REVIEWER COMMENTS

The manuscript by Heedt et al, reports a novel fabrication scheme for realizing semiconductor/superconductor hybrid nanowire devices. The method relies on clever preparation of the device substrate, manipulation of nanowires, and a new hydrogen cleaning procedure for achieving clean interfaces between the nanowires and superconductors. The method minimizes or eliminates the process steps required after establishing the semiconductor/superconductor interface which is known to be crucial for device performance. Compared to recent developments of shadow-approaches which eliminate certain process steps by combining shadow structures directly with the growth of the nanowires, the present method enables a considerable flexibility in device design and also opens up for unique and important device geometries as electrical connection to the superconductor shells can be achieved. The merits of the method are backed up by comprehensive low temperature electrical characterization of devices and a substantial and detailed supplementary information providing all necessary details. The invention of this new approach and the presented results constitute a significant step forwar

Unique orientations of the Al-covered facets on hexagonal nanowires.

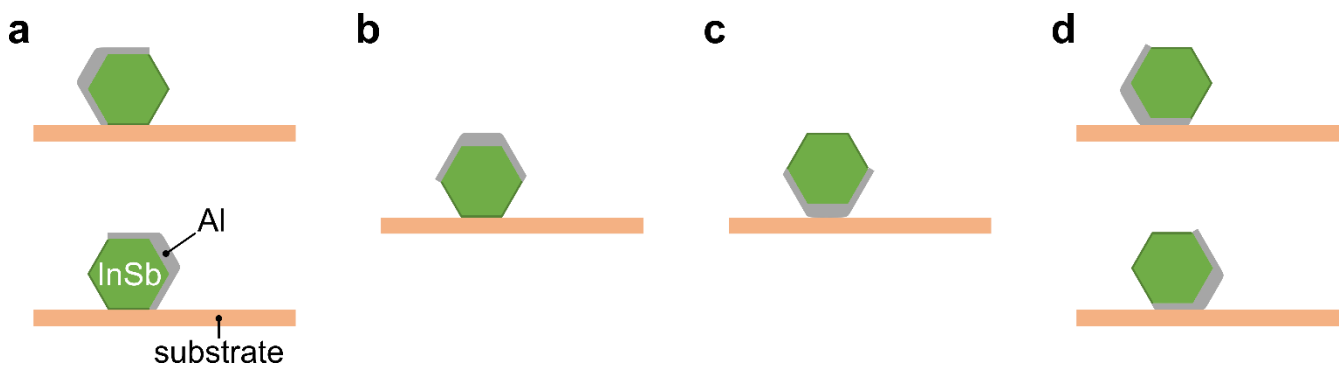
1) As stated in the abstract the new shadow-wall procedure "offers substantial advances in device quality and reproducibility". Reproducibility is, however, is not systematically considered in the manuscript. Could the authors include a discussion of the reproducibility of the results of shadow-wall devices compared to conventional devices. Also, it is not clear what the "substantial advance in device quality" refers to, and I suggest the authors include this discussion as well maybe as a part of the summary.

Shadow-wall lithography offers the same interface quality as state-of-the-art in-situ deposition methods, which allow for hard gaps, but it effectively removes the variations inherent to other methods and introduces considerable flexibility and fundamentally new device designs. Our approach reduces the risk of ageing of the hybrid interface by requiring at most a single fabrication step and it provides a large number of nominally identical devices. By design, all nanowires are aligned along the same direction, which is a bonus feature of the shadow-wall technique, as it simplifies the alignment of the magnetic field along the wire axis. This is a key requirement to search for a topological phase in all available hybrid nanowire devices on a given chip.
